RFT 26-083 Interior Renovations & Air Conditioner Upgrades at Frontenac PS

The following, issued by the Halton District School Board (HDSB) June 18, 2026, shall be incorporated in the specifications and shall form part of the proposal document for the above.

TENDER ADDENDUM NO. 1
2026.06.17

Interior Renovations and Air Conditioner Upgrades at Frontenac Public School
Halton District School Board RFT 26-083
5140 Pinedale Avenue, Burlington, Ontario

Proj. No.: 26001

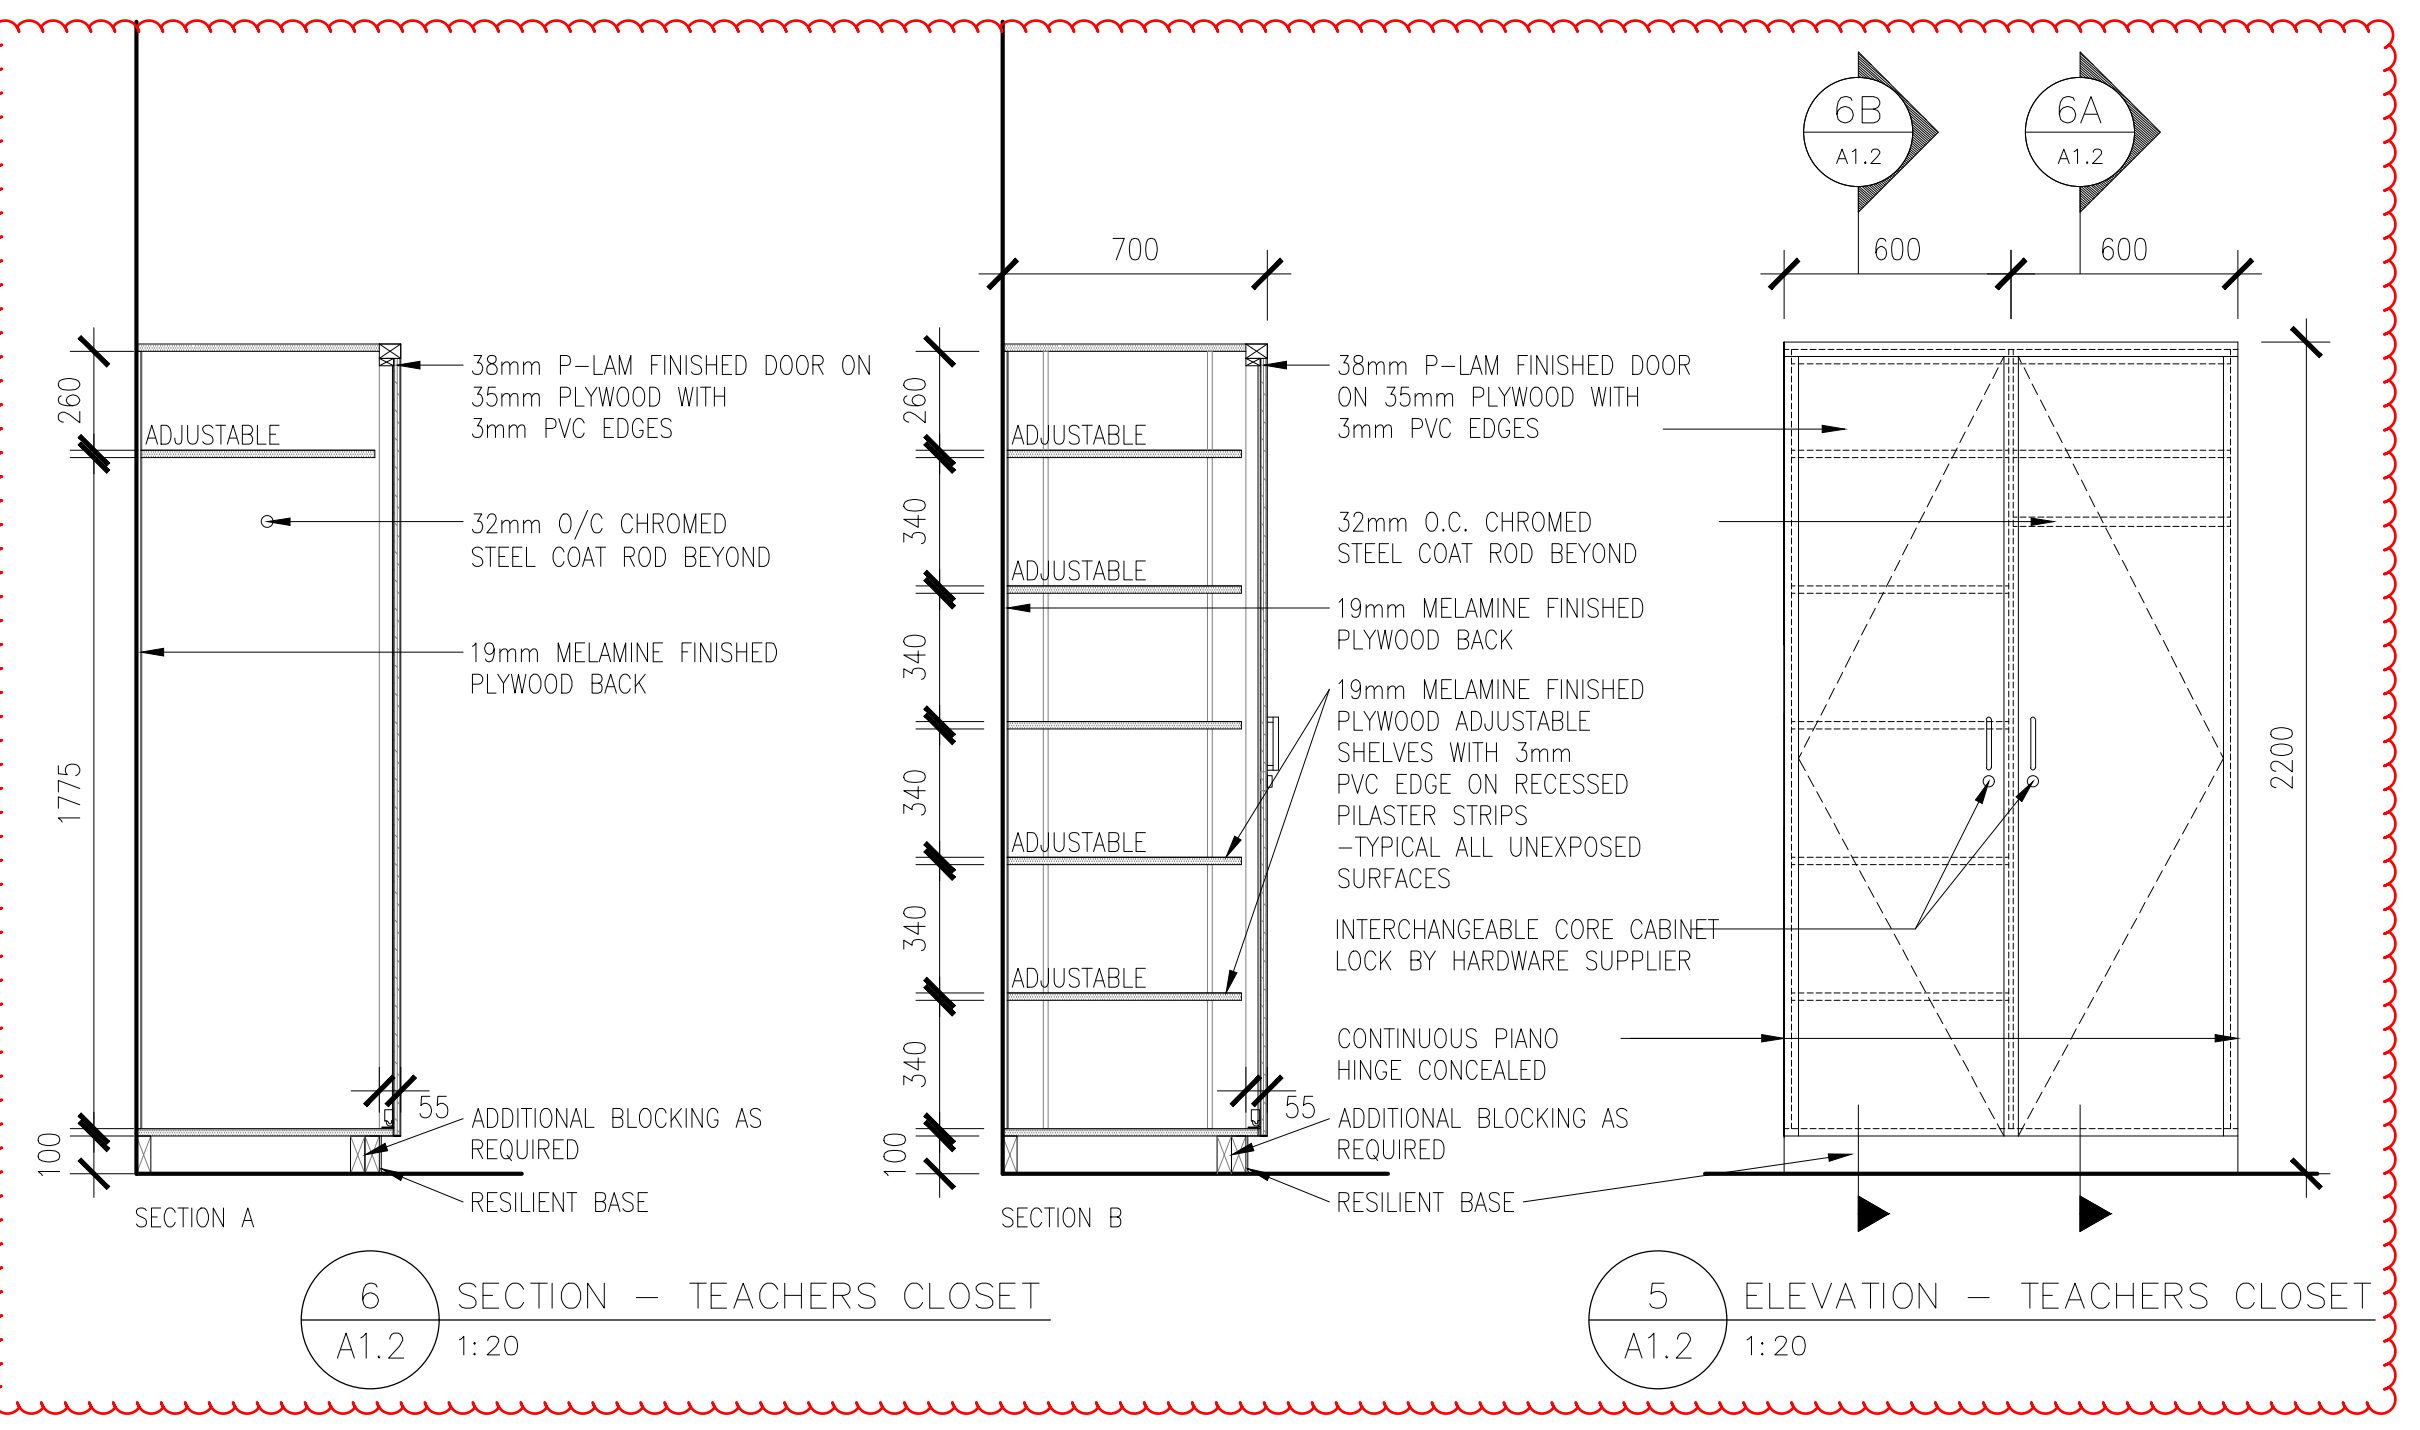
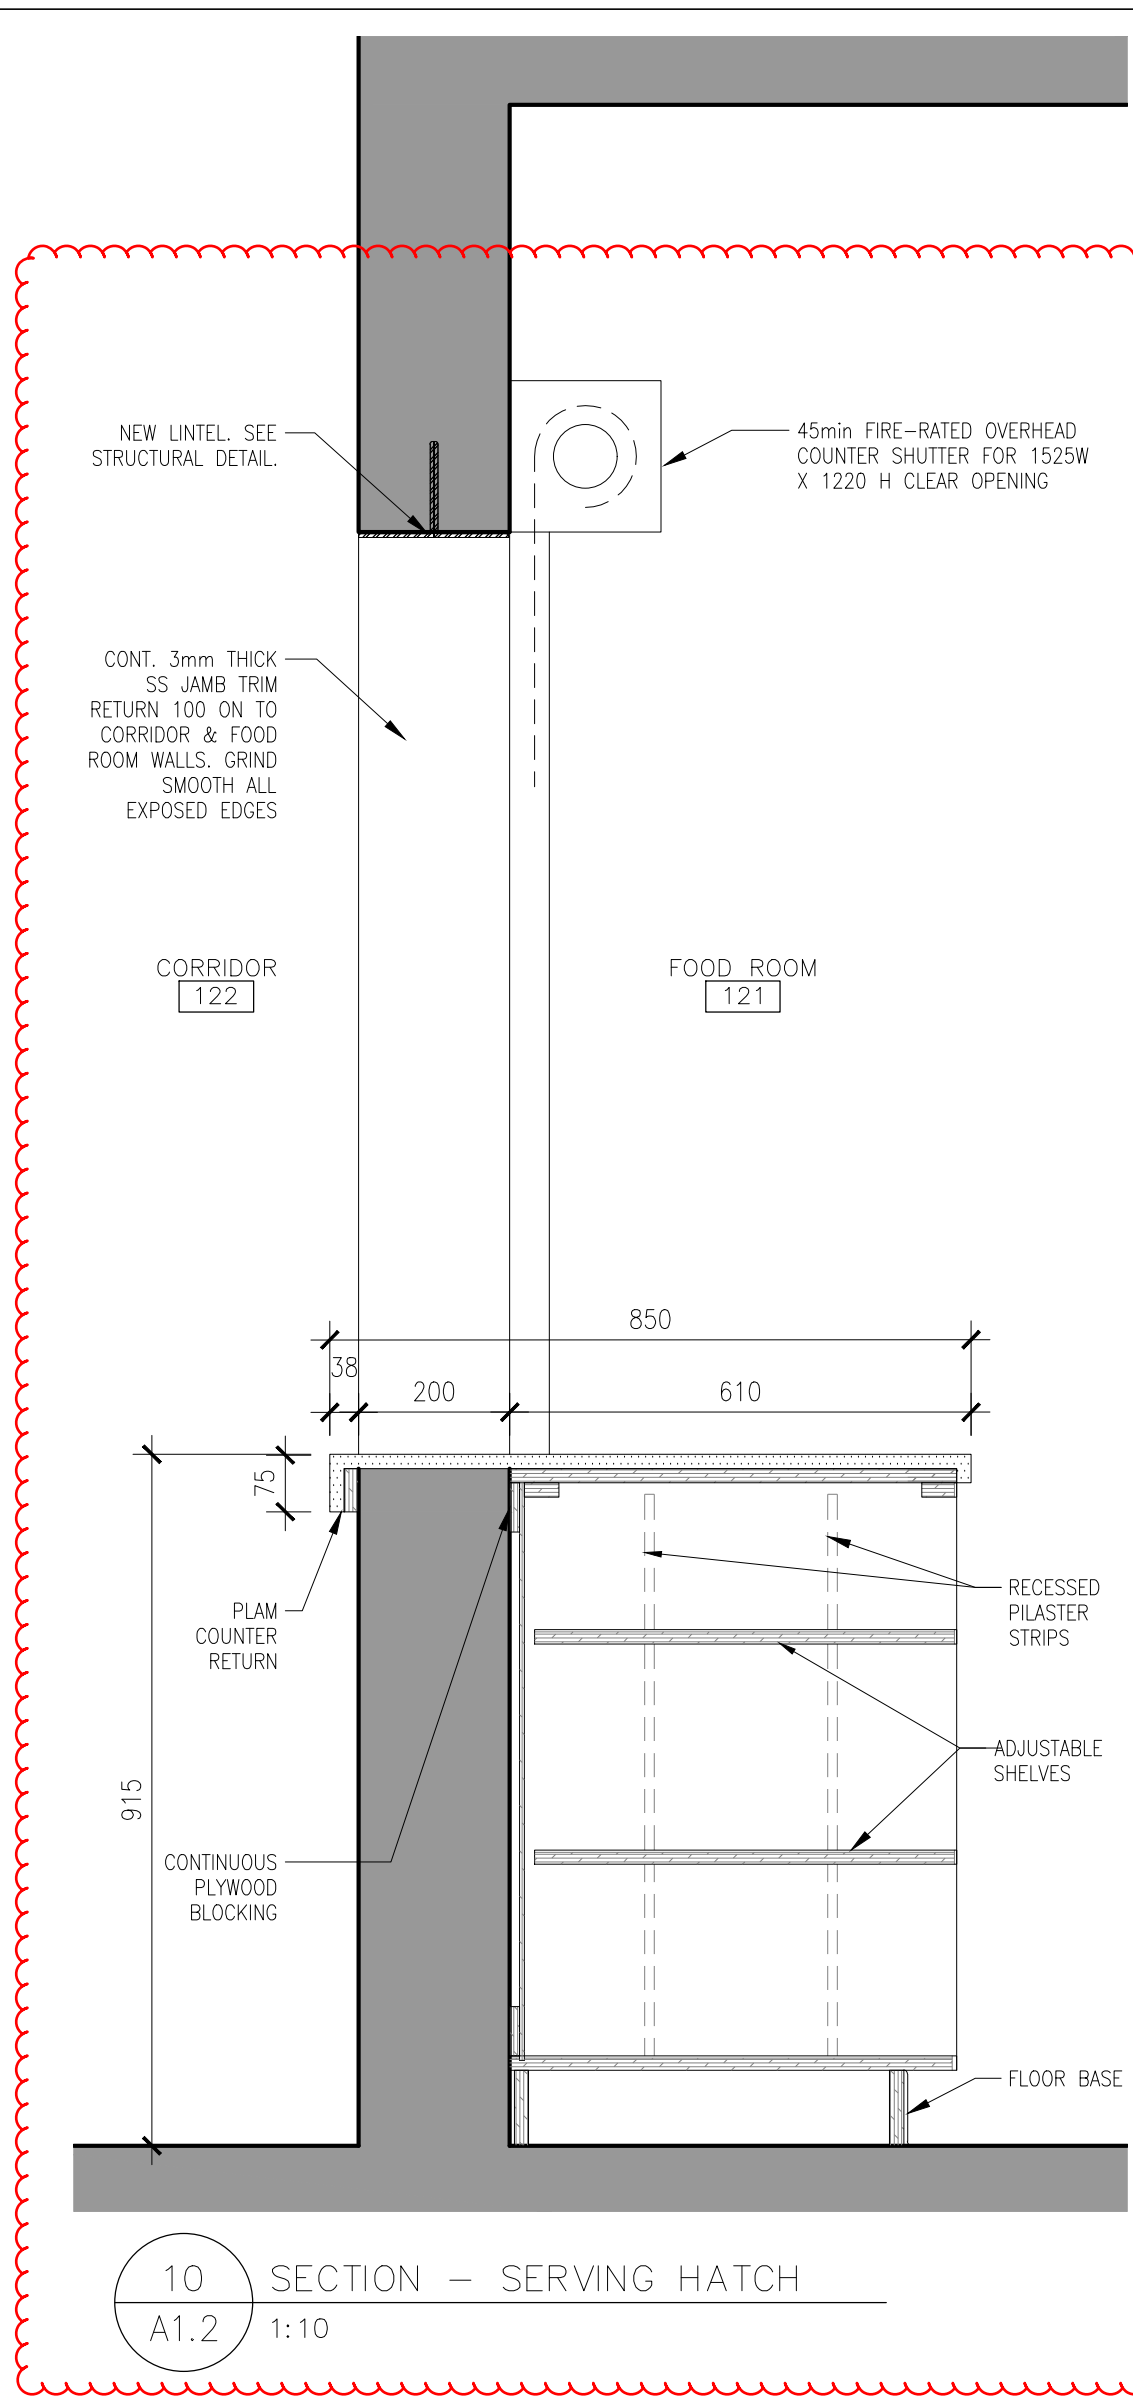
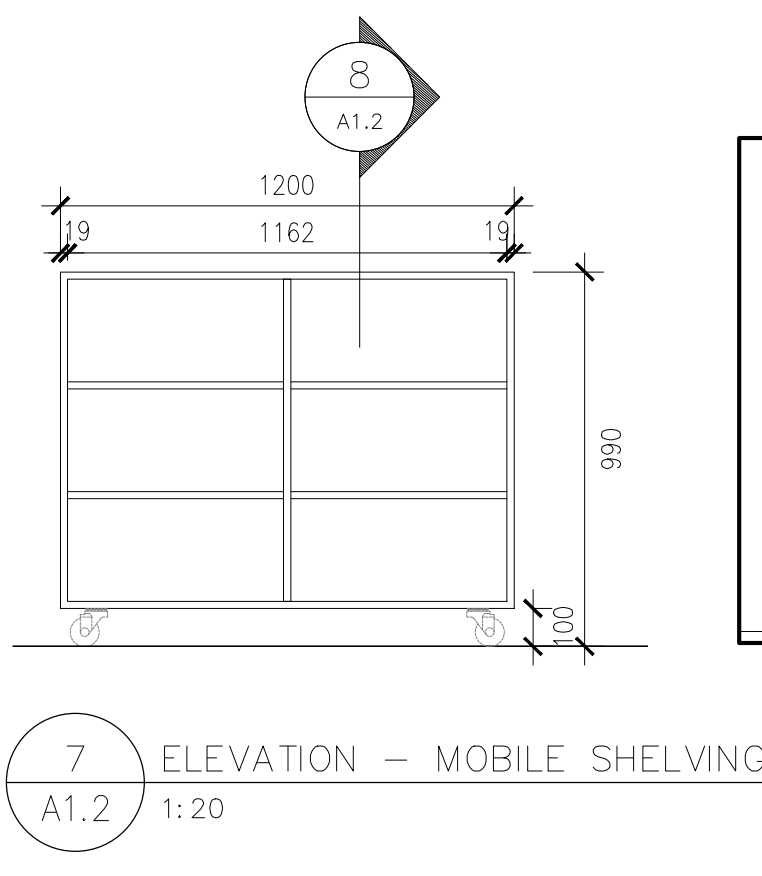
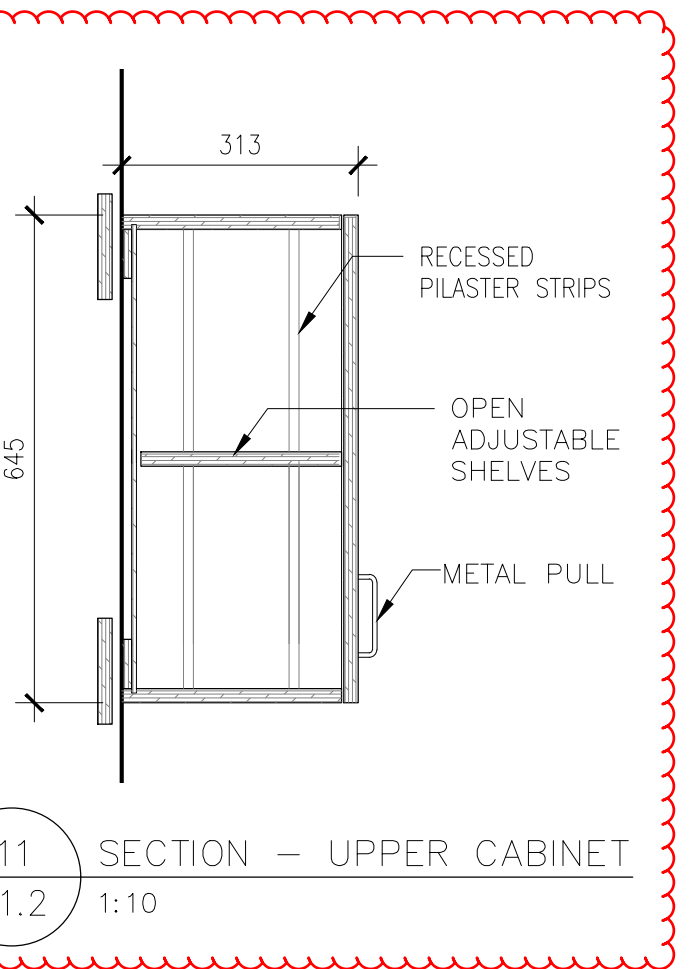
1.3: Drawing A1.1 Demolition & Proposed Floor Plans – Room 114:

1. ADD to Interior Elevations 1/A1.1 and 2/A1.1 reference bubbles to detail millwork sections. See attached revised drawing A1.1 with bubbled revisions.
2. ADD Millwork Section Detail 11/A1.1 and Interior Elevations 3/A1.1, 4/A1.1, 10/A1.1 and 12/A1.1. See attached revised drawing A1.1 with bubbled revisions.
